East Perth project, Claisebrook Inlet

East Perth Redevelopment Authority

**Report and recommendations
of the Environmental Protection Authority**

**Environmental Protection Authority
Perth, Western Australia
Bulletin 653
October, 1992**

Figure 1: Claisebrook Inlet, East Perth

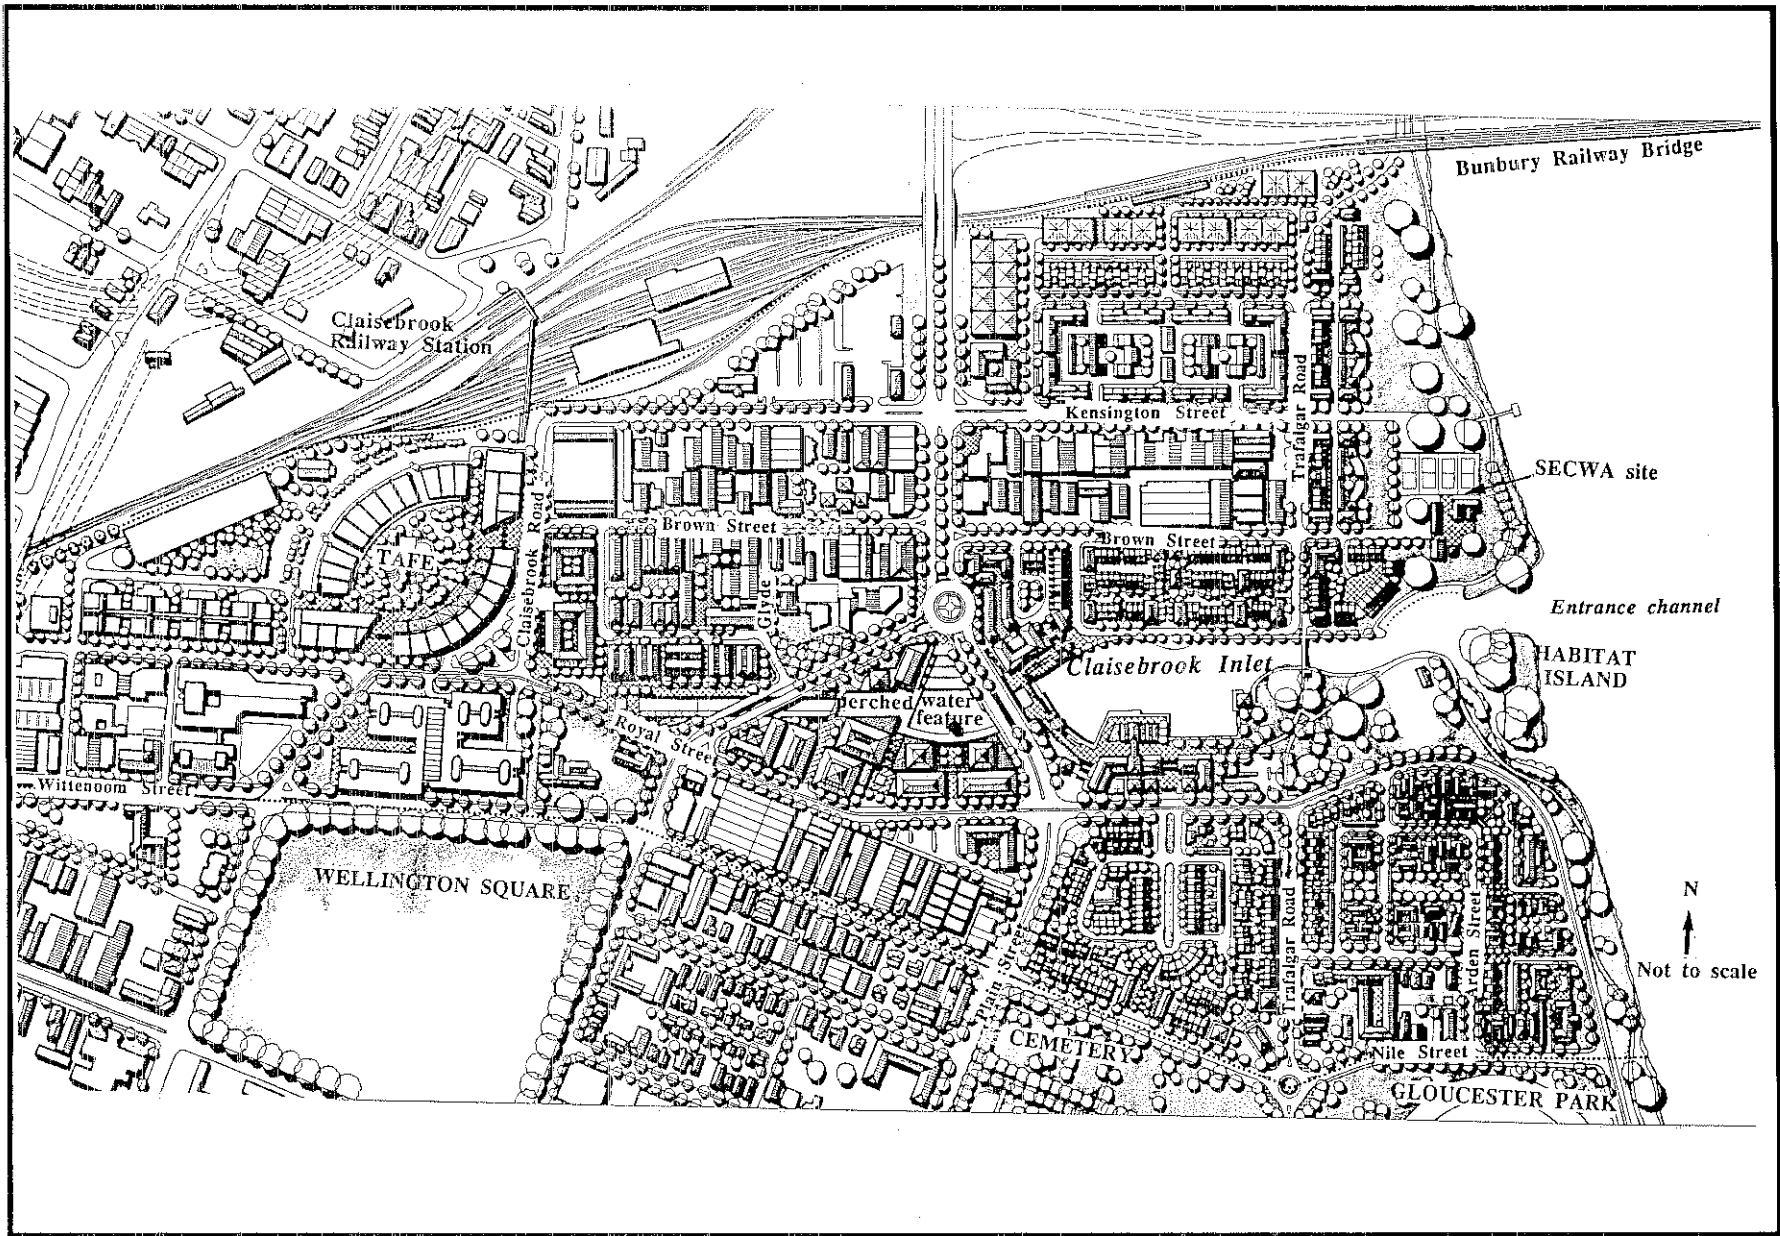
The East Perth Redevelopment Authority's proposal includes an artificial waterway, to be called Claisebrook Inlet and is described in the Public Environmental Review. The Inlet basically will be a canal waterway that provides an aesthetic and direct connection with the Swan River and will have publicly owned facilities along its edge. The construction of the waterway and adjacent edge facilities has the following components: an entrance channel, main basin, perched water feature, habitat island and surrounding hard and soft edge treatments and facilities (Figure 1).

The Claisebrook Inlet will be constructed at the outlet of the existing Claisebrook Drain stormwater system. The proponent proposes to construct an extension of the main drain to enter the Inlet and to construct a low flow diversion drain to divert some of the more contaminated drain water from the Inlet to discharge directly into the river downstream of the existing outlet. In response to concerns about contamination in the drain, the proponent considered two options of discharging the diversion drain either into a channel which would separate the proposed habitat island from the new river bank or further to the south as shown in the Public Environmental Review.

Figure 2: Claisebrook main drain catchment

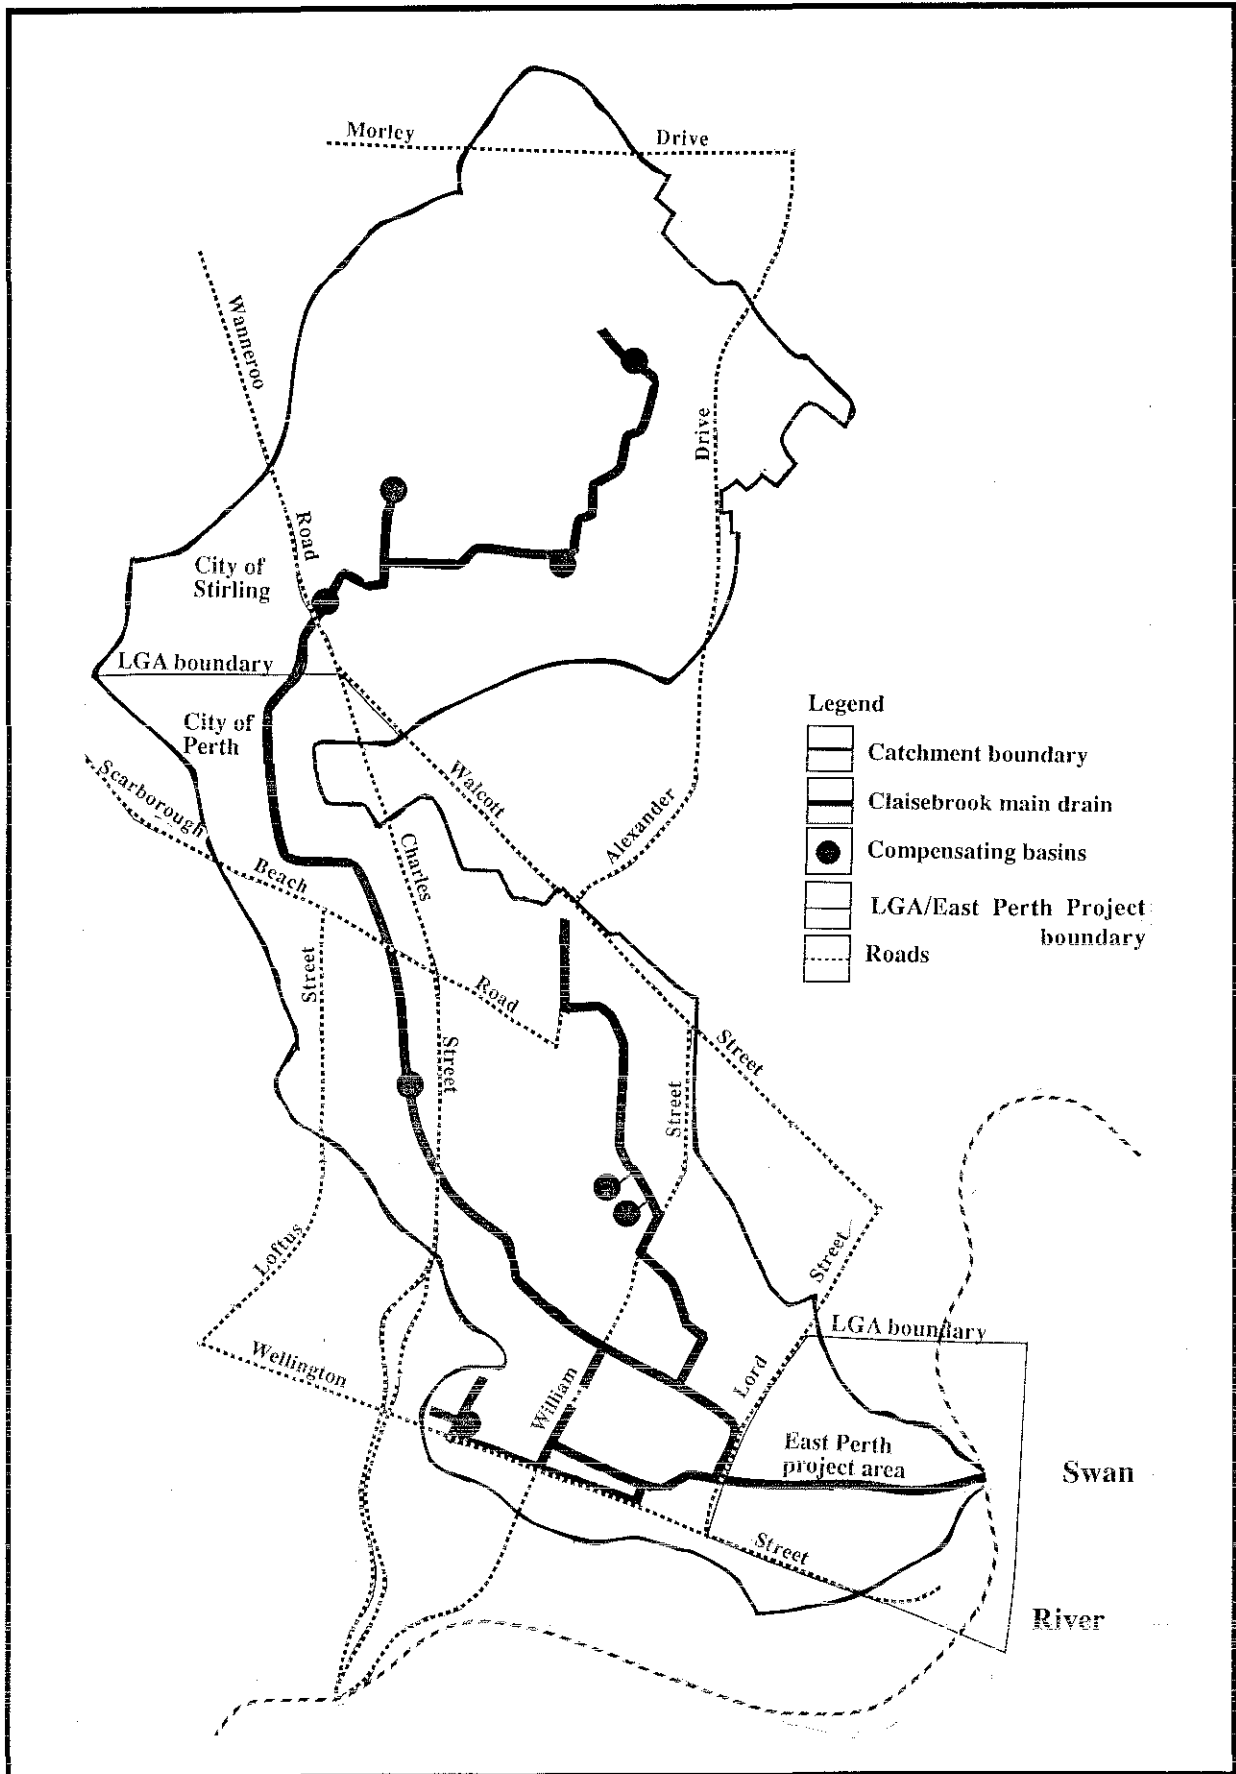
It is recognised that the contamination of the drainage water arises mainly from the catchment outside the East Perth Project area (Figure 2). The East Perth Redevelopment Authority is thus only one agency responsible for management of part of Claisebrook Drain in the long term. The Water Authority of WA, the Swan River Trust, the Local Government Authorities, the industrial developments within the catchment and the wider community should all be involved if a clean-up and management programme is to be successful.

The Environmental Protection Authority considers that a catchment management plan should be drawn up for the management of the Claisebrook Main Drain catchment to reduce the levels of contamination entering the Inlet and the river from the drain.

The Environmental Protection Authority recommends that the State Government have prepared and implemented a catchment management programme for the Claisebrook Main Drain catchment, to the requirements of the Ministers for the Environment, Water Resources and Local Government.
